MEMORANDUM

MFG PROJECT: 180734

TO: Dr. A. K. Ibrahim, U.S. Nuclear Regulatory Commission
FROM: Roslyn Stern, Clint Strachan
DATE: December 21, 2004
SUBJECT: Sequoyah Fuels Corporation Site, Seismicity Issues
COPY: Craig Harlin, Sequoyah Fuels Corporation

FIGURE 1
Magnitude-Frequency Curve
Ozark Uplift

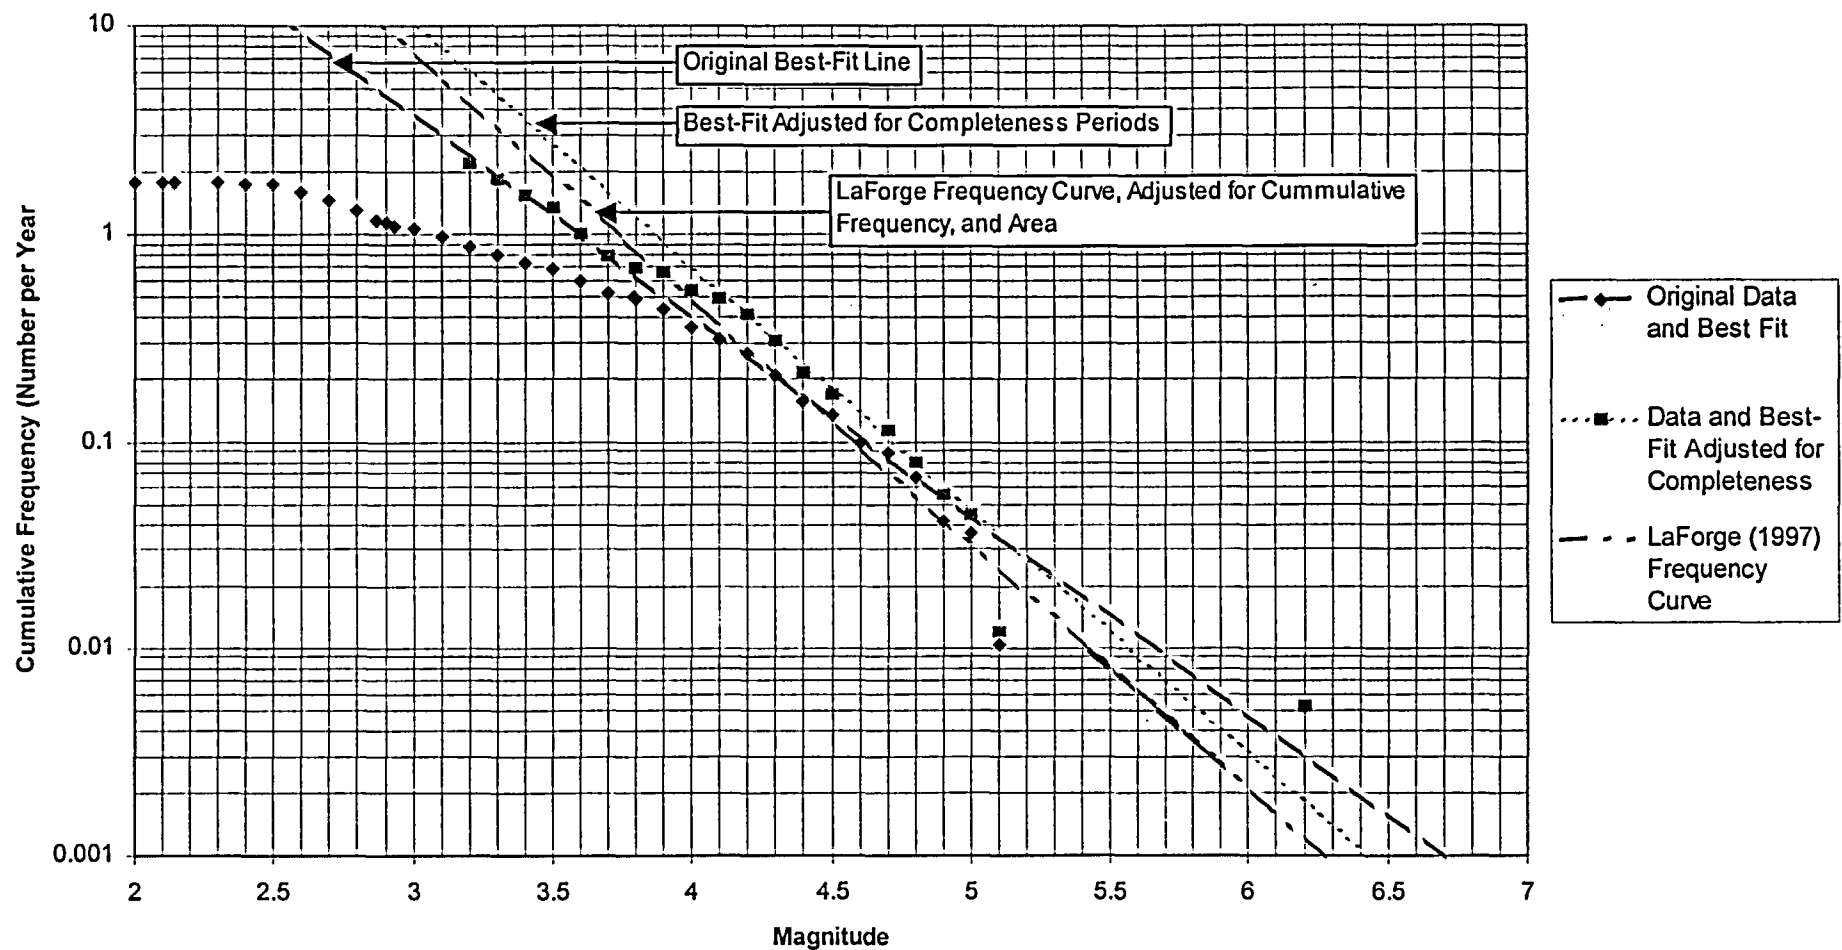
4. Assuming the random earthquake events can be limited to a magnitude of 6.2, what is the calculated peak horizontal acceleration if this event is applied 15 km from the site?

- LaForge used a more rigorous technique to develop the recurrence interval of seismic events. This included correcting for completeness record and declustering dependent events. Figure 1 shows the original magnitude frequency curve developed by MFG, a revised MFG curve corrected for completeness record, and the curve developed by LaForge for Zone 3. It should be noted that LaForge's curve has been modified as presented in LaForge (1997) to represent cumulative frequency, rather than incremental, and adjusted for an equivalent area of the Ozark Uplift. The LaForge and MFG revised curves are similar, especially when considering that the source zones are slightly different (eastern Oklahoma of 65,000 km² versus the Ozark Uplift of 322,000 km²).

Using Atkinson and Boore (1995) attenuation equations, the computed horizontal acceleration is 0.46 g. Using the original magnitude-frequency curve as shown in Figure 1, the annual probability of having an event of this size occur within this distance is approximately 1/75,000. If the magnitude-frequency curve from LaForge (1997) is used (discussed further in comment 5), the annual probability of occurrence is 1/900,000.

Figure 2. Mean hazard curves for PHA, McGee Creek Dam

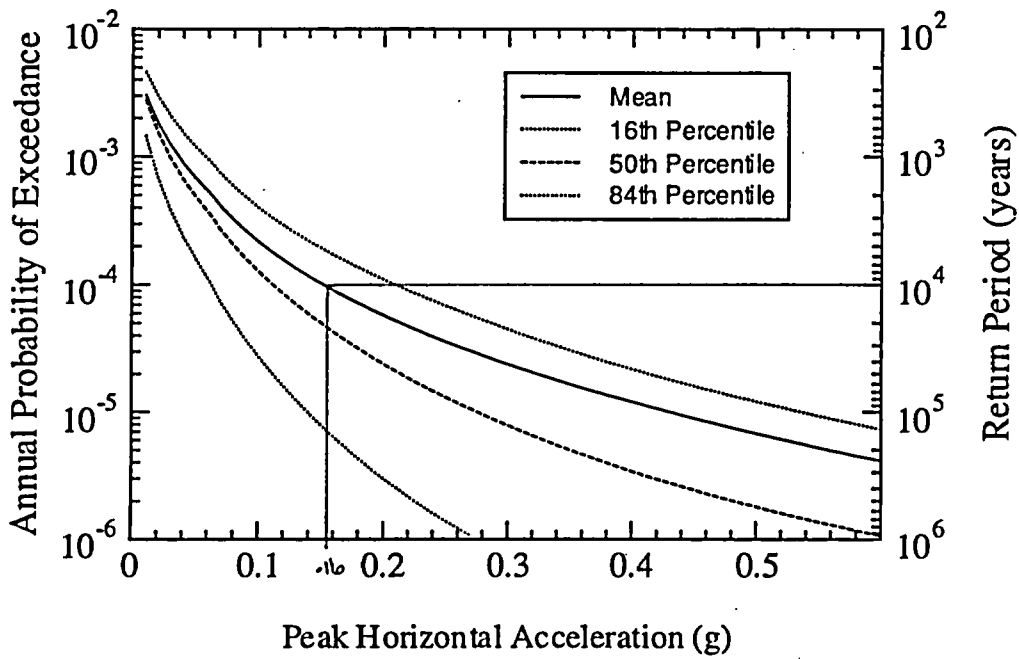
5. Dr. Ibrahim commented that he didn't feel comfortable with the explanation of using concentric circles about the site as source zones for the random earthquake analysis, and didn't agree with the larger circles (i.e. source zones) having larger 10,000-year earthquake events associated with them as presented in Tables 1 and 3 of the September 7, 2004 letter. Provide additional documentation to support technique and results for the random earthquake analysis.

As shown in the attached figure (Figure 2, draft report dated 10/5/04, shown in Attachment 2), the peak horizontal acceleration associated with the mean percentile, 1E-4 annual probability of exceedance is 0.16g.
